## AUTOMATIC TRANSMITTER SHUTDOWN

ASTRO-200

MODIFICATION

METER DRIVER

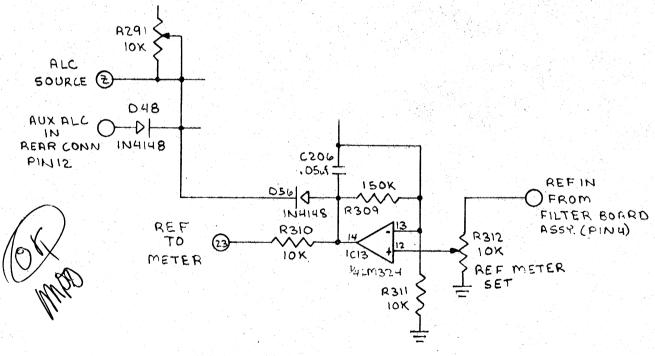
To assure transmitter final amplifier transistors are not over stressed when loaded into a VSWR greater than 2, a shut down circuit has been added to the ALC control. This circuit limits peak power and CW power to approximatly 100 watts into a VSWR of 2. For VSWR greater than 2 the power is reduced proportionally with minimum power available for VSWR greater than about 4.

The shutdown circuit limits power when mismatched, therefore full scale FWD readings will not be possible when a VSWR greater than 2 is present. For this reason the REF mode VSWR readings are not accurate and must be scaled relative to the percent of full scale in FWD mode.
